ADDENDUM NO.: THREE

DATE OF ADDENDUM: January 12, 2016

**NEW MANUFACTURING TECHNOLOGY CENTER
ASNUNTUCK COMMUNITY COLLEGE
170 ELM STREET
ENFIELD, CT
BI-CTC-488**

DATE 01/11/2016
 COPYRIGHT ©
 Moser Pilon Nelson Architects
 SCALE: NONE
 SKETCH NO.
AD3-SK2-EP2.5

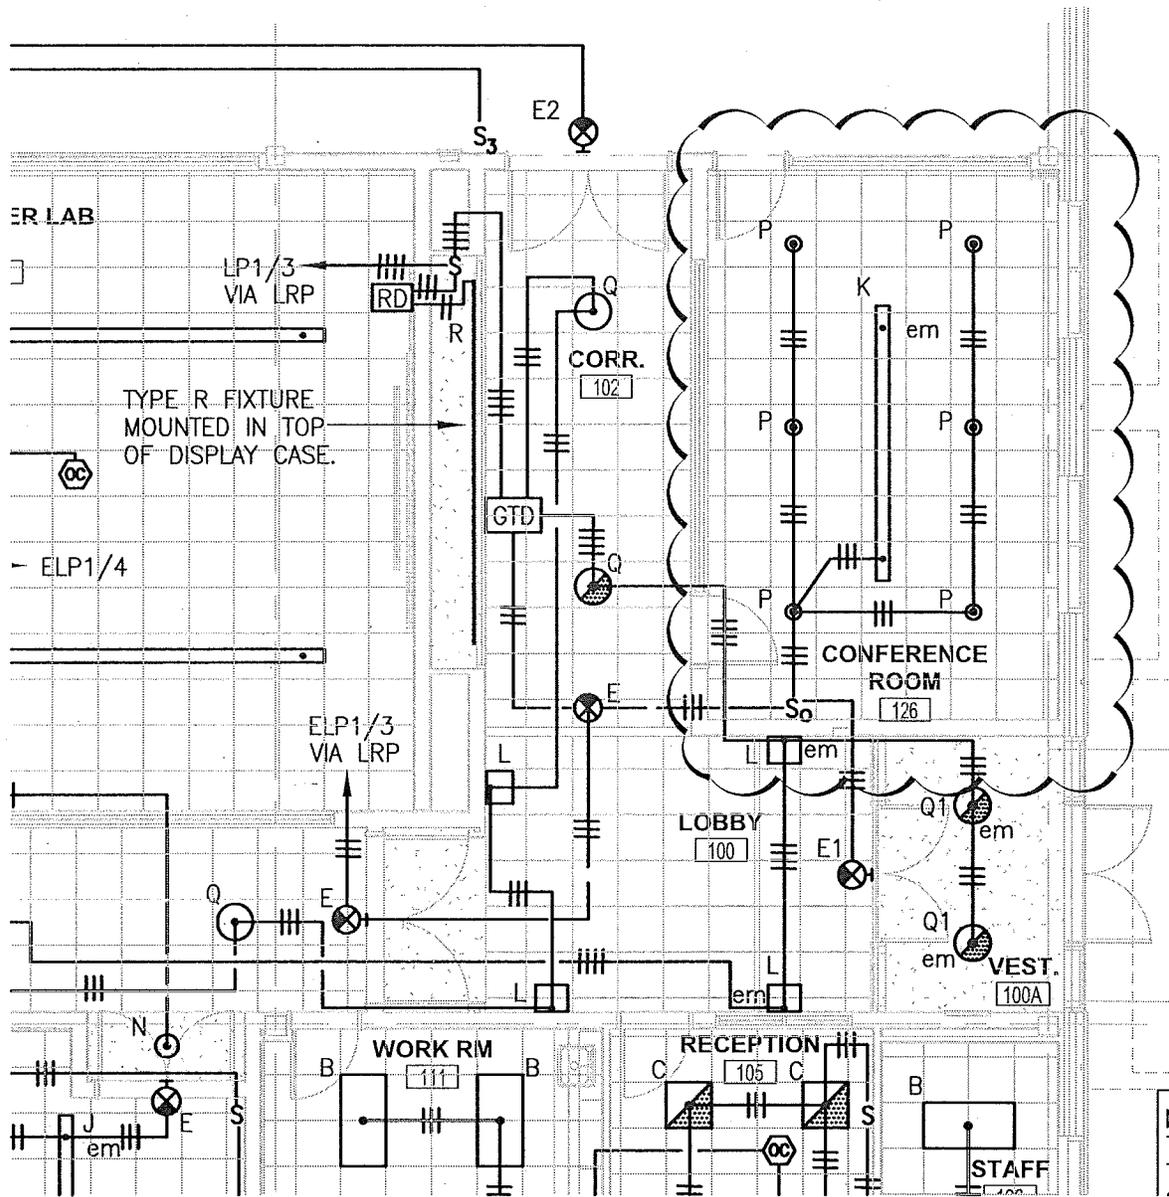
DRAWING EP2.5 – Refer to Addendum #3 sketch AD3-SK2-EP2.5,for panelboard REVISIONS.

DATE 01/11/2016
COPYRIGHT © Moser Pilon Nelson Architects
SCALE: NONE
SKETCH NO. AD3-SK1-EL2.0

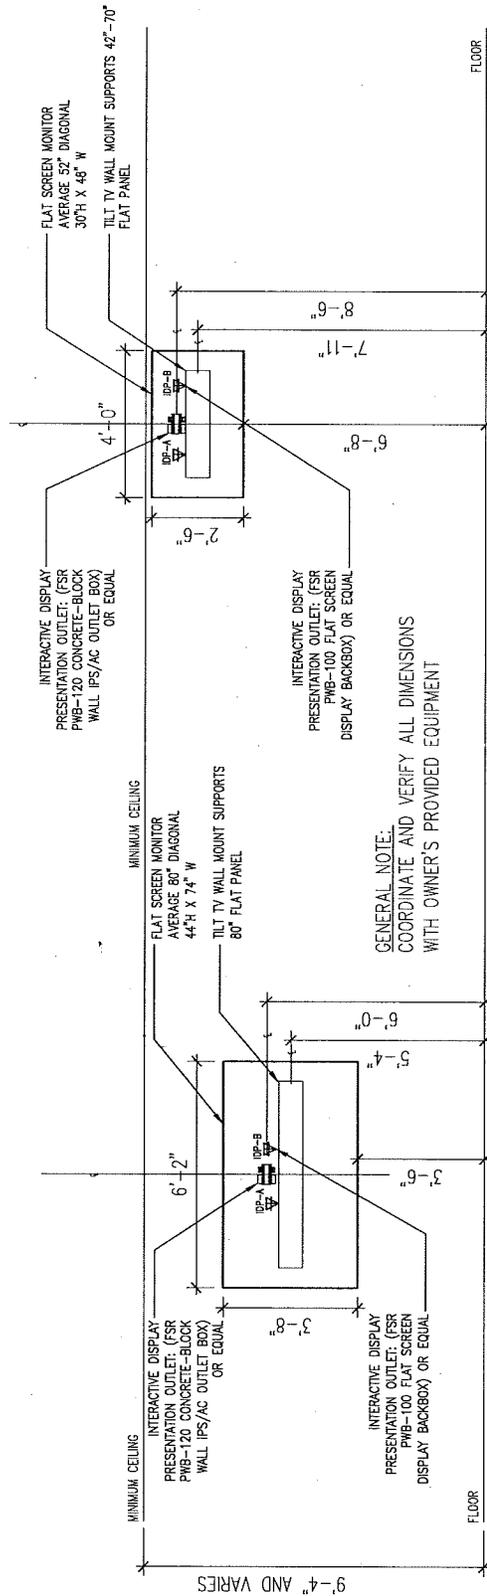
DRAWING EL2.0 – Refer to Addendum #3 sketch AD3-SK1-EL2.0 for CHANGE to type D light fixture.
